SUBJECT: Forwards supplemental info re implementation of AMSAC sys.

H. B. ROBINSON STEAM ELECTRIC PLANT, UNIT NO. 2  
DOCKET NO. 50-261/LICENSE NO. DPR-23  
SUPPLEMENTAL PLANT-SPECIFIC AMSAC INFORMATION

## ATTACHMENT 1

# HBR AMSAC FUNCTIONAL DIAGRAM

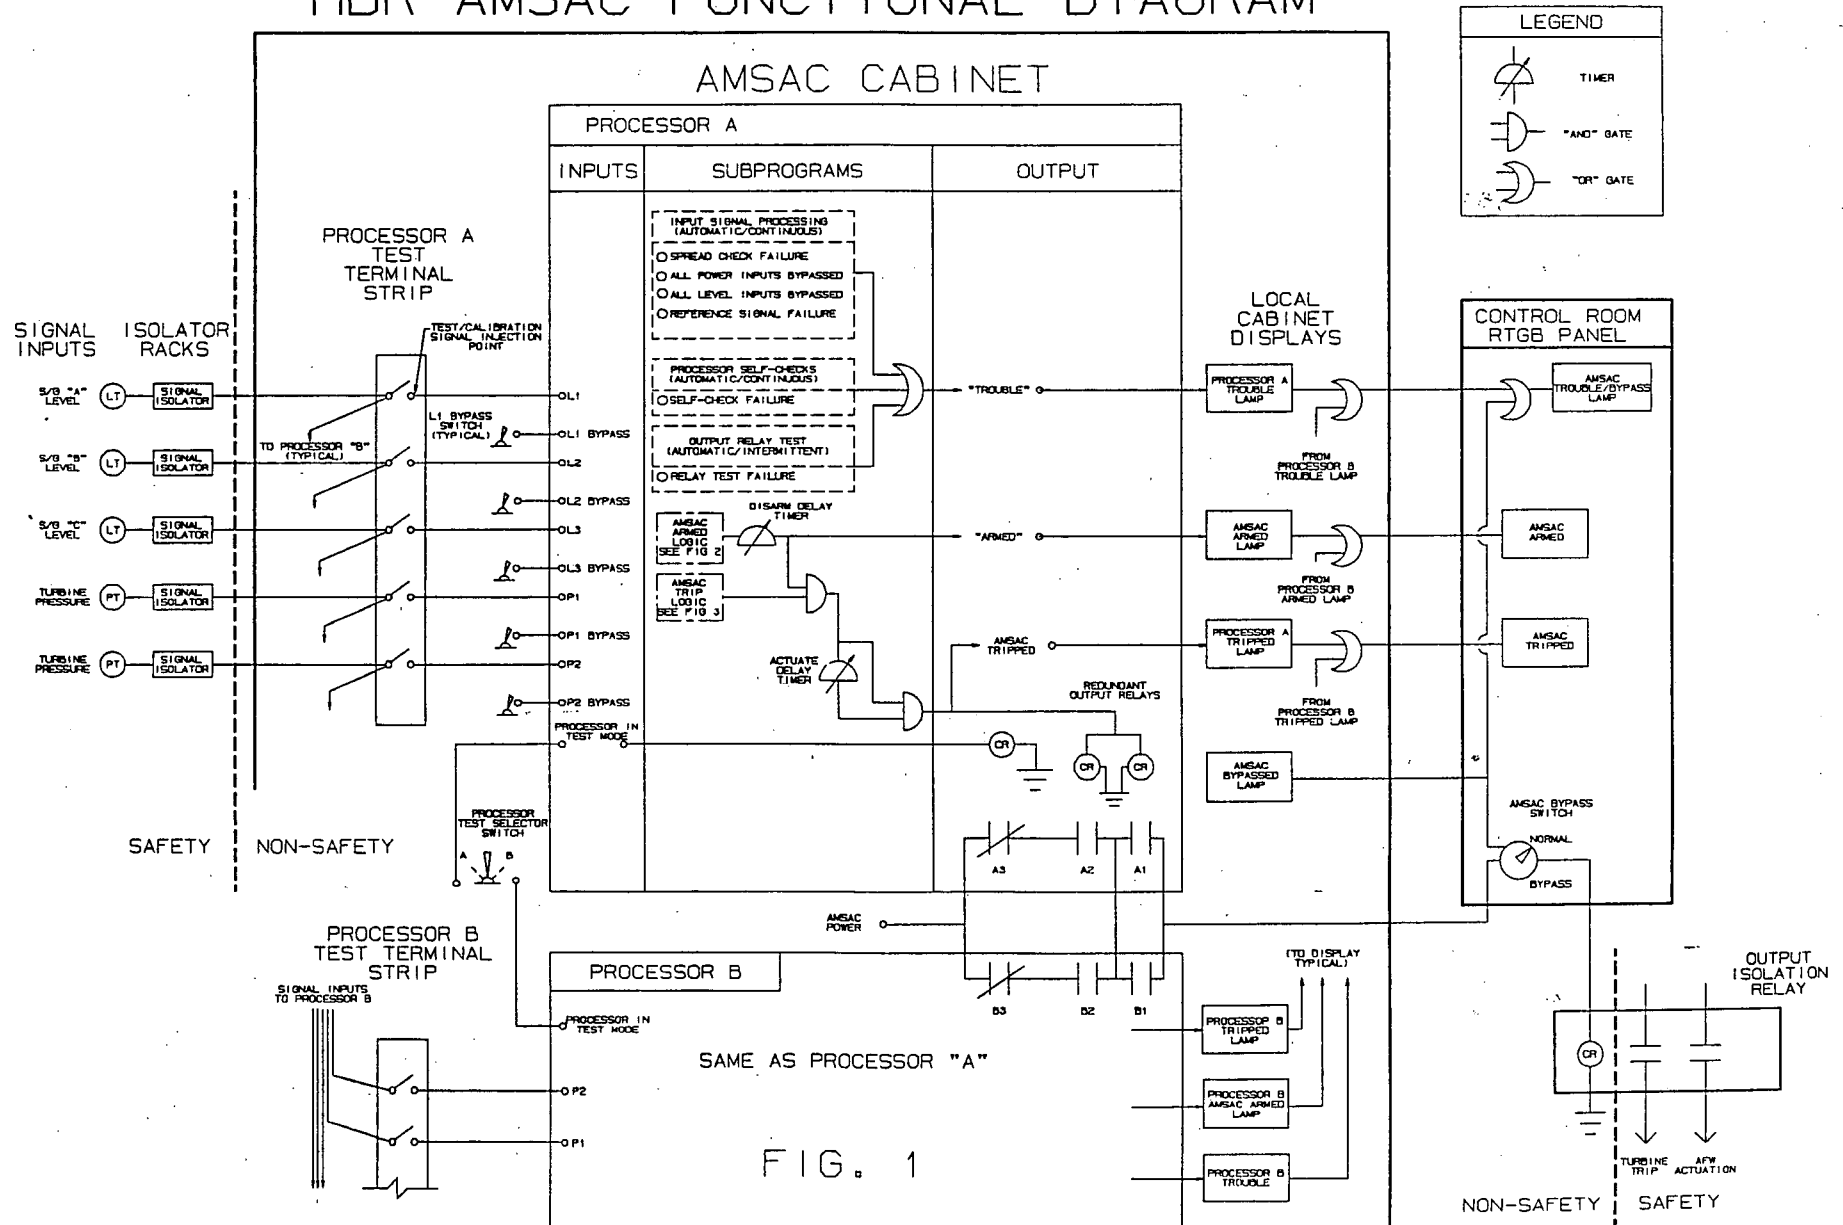
Provide a simplified Logic Diagram.

The information concerning testing capabilities (Section 12) provides a discussion of the system capabilities which will help explain the Functional Diagram.

**RESPONSE:** The CP&L AMSAC system utilizes the capabilities of a pair of redundant microprocessors in a moderately sophisticated scheme in order to enhance system operability and reliability. As a result, the system does not lend itself to the type of simplified logic diagrams typically depicted in the AMSAC WCAPs. However, in order to facilitate the staff's review, a simplified Functional Diagram (Figure 1) has been attached to provide an overall view of the AMSAC system from its interface with the existing plant input signal to its interface with the output actuation circuitry. To maintain the simplicity of the diagram, the more relevant functions of the microprocessors have been depicted as subprograms, the outputs of which feed the overall program logic. The detailed operations of these subprograms have been provided on separate figures (Figures 2 and 3). Although all of the functions and capabilities of the system are not depicted by the diagram, CP&L believes that the attached figures provide the level of detail required for the NRC to perform its review.

FIGURE 4

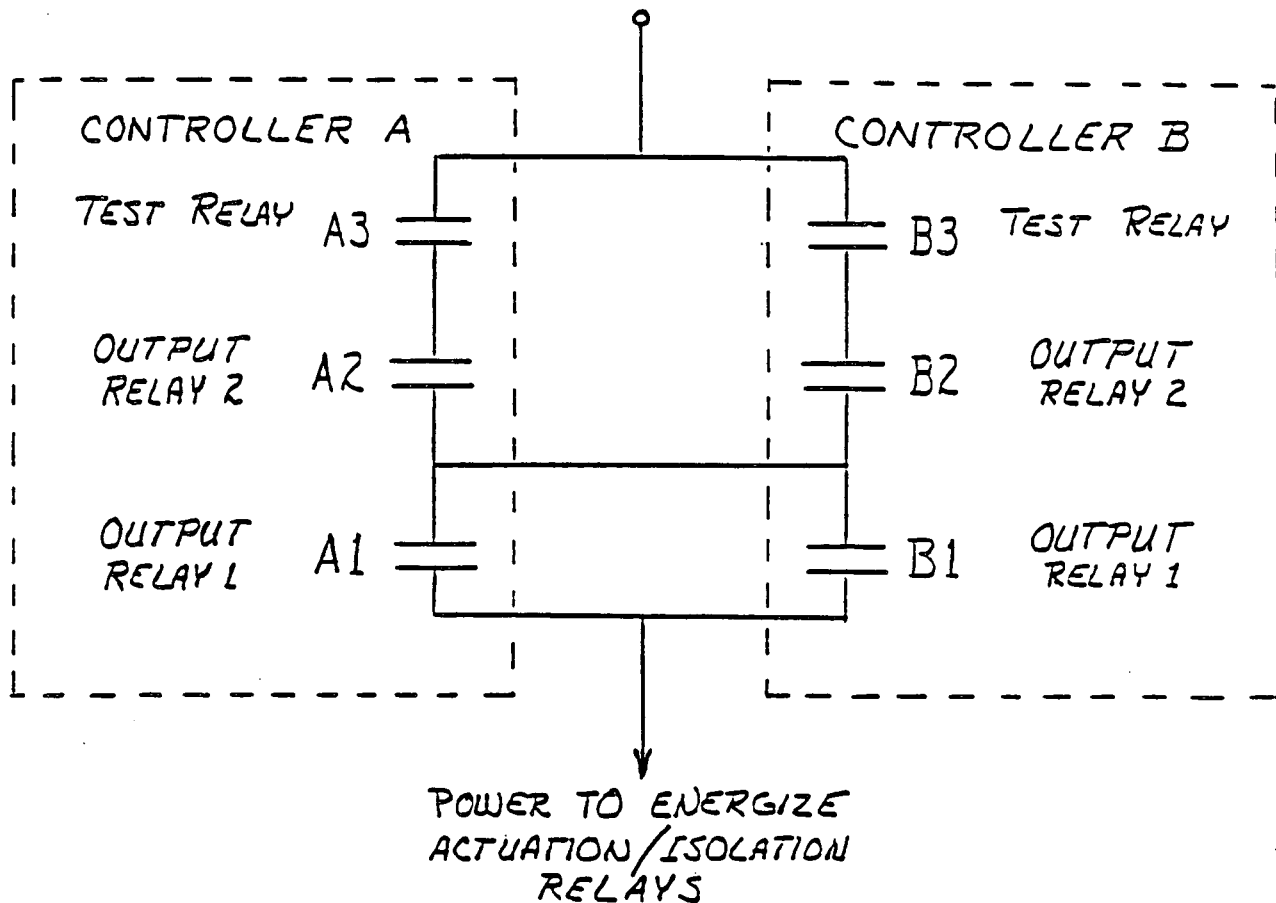
**RESPONSE:** As identified during the course of the subject conference call, a bypass switch will not be provided at the local AMSAC panel as shown in Figure B of the original submittal. This switch is provided in the Control Room only.
